Flight Procedures Cover Page	Task Action: FLIGHT CHECK	Task Type: IAP	Estimated Chart Date: 02/20/2025	APWS Task ID: 8EED4088BCC848B68ADF80BB72BE12C4	APWS Project ID: FB92122B929342D7B2D3181905E5ECE6
Procedure: RNAV (RNP) Z RWY 27 AMDT 1		Enroute: NO	Specialist: Mitchell, Tyler		Agreement Number:
Airport ID: KCVG			Airport City: COVINGTON		State: KY
Facility ID:	Facility Type:	Flight Inspection Remark Type: New FC Slot			
<div>Procedure Comments: PROCEDURE REDESIGN</div> <div>APPROVAL LETTER - FIBSU MANDATORY ALT APPROVAL LETTER - ZALD MANDATORY ALT</div> <div>CONTACT CASIMIR TABAKA 405-954-7931</div> <div>QUALITY 26 CHECKED</div> <div>QUALITY 38 CHECKED</div>

FIPC BASIC FORM							
PROCEDURE: RNAV (RNP) Z RWY 27 AMDT 1			AIRPORT NAME: CINCINNATI/NORTHERN KENTUCKY		AIRPORT ID: KCVG	SPECIAL CONTROL NO: AG-01-220-25	
FAC ID: KCVG27.01Z		CITY: COVINGTON			ST: KY	ORIG CHART DATE: 06/12/2025	
DFL TYPE: PROC/P	THIRD PARTY: <input type="checkbox"/> YES	EST. TIME ON SITE: 0.4	REIMB. NUMBER:		PTS TASK ID: 8EED4088BCC848B68ADF80BB72BE12C4		
PREFLIGHT NOTES							
REVIEWER:					DATE:		
COMMENTS:					CHECK ONE:		
					<input type="checkbox"/> FLT CK REQ <input type="checkbox"/> NFCR <input ty

RNAV (RNP) Z RWY 27

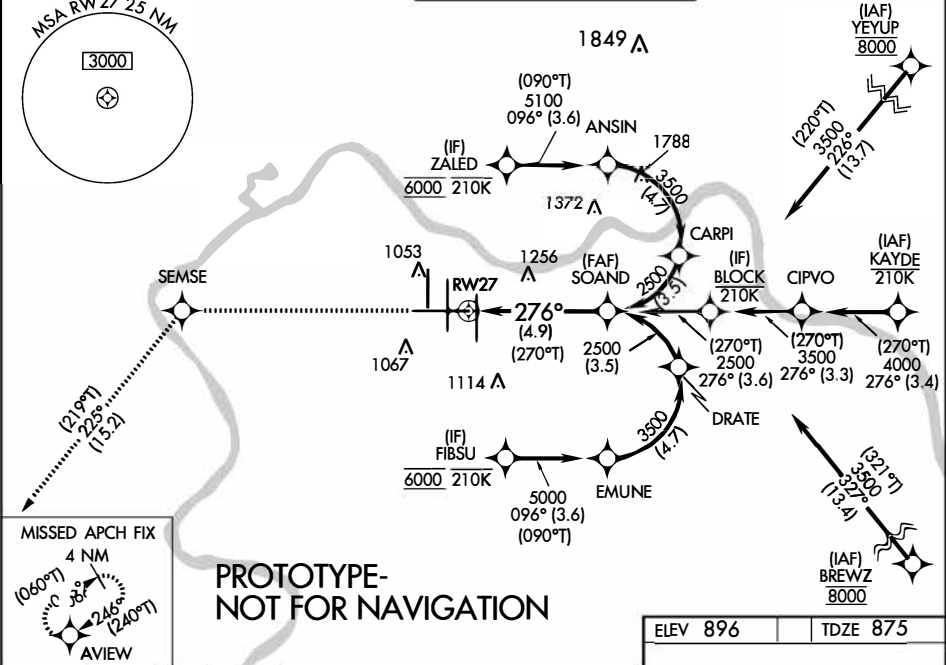
Your request to chart a mandatory crossing altitude of 6000 feet at FIBSU on the "RNAV (RNP) Z RWY 27, AMDT 1" at Cincinnati/Northern Kentucky Intl, Covington, KY was discussed at the Flight Standards Procedure Review Board on 01/04/2024 and is approved.

KCVG TRACON requests AFS approval to chart a mandatory altitude restriction at the following fix: FIBSU at 6000ft MSL for the RNAV RNP Z RWY 27 instrument approach procedure for Cincinnati-Northern Kentucky International Airport (KCVG).

Therefore, Cincinnati TRACON requests to chart the mandatory restriction at FIBSU on the RNAV RNP Z RWY 27. This is an ATC operational request to ensure vertical separation between aircraft on the approach and other TRACON traffic.

Your request to chart a mandatory crossing altitude of 6000 feet at ZALED on the "RNAV (RNP) Z RWY 27, AMDT 1" at Cincinnati/Northern Kentucky Intl, Covington, KY was discussed at the Flight Standards Procedure Review Board on 01/04/2024 and is approved.

KCVG TRACON requests AFS approval to chart a mandatory altitude restriction at the following fix: ZALED at 6000ft MSL for the RNAV RNP Z RWY 27 instrument approach procedure for Cincinnati-Northern Kentucky International Airport (KCVG).

Therefore, Cincinnati TRACON requests to chart the mandatory restriction at ZALED on the RNAV RNP Z RWY 27. This is an ATC operational request to ensure vertical separation between aircraft on the approach and other TRACON traffic.

Your request to chart a mandatory crossing altitude of 6000 feet at FIBSU on the “RNAV (RNP) Z RWY 27, AMDT 1” at Cincinnati/Northern Kentucky Intl, Covington, KY was discussed at the Flight Standards Procedure Review Board on 01/04/2024 and is approved.

Your request to chart a mandatory crossing altitude of 6000 feet at ZALED on the "RNAV (RNP) Z RWY 27, AMDT 1" at Cincinnati/Northern Kentucky Intl, Covington, KY was discussed at the Flight Standards Procedure Review Board on 01/04/2024 and is approved.
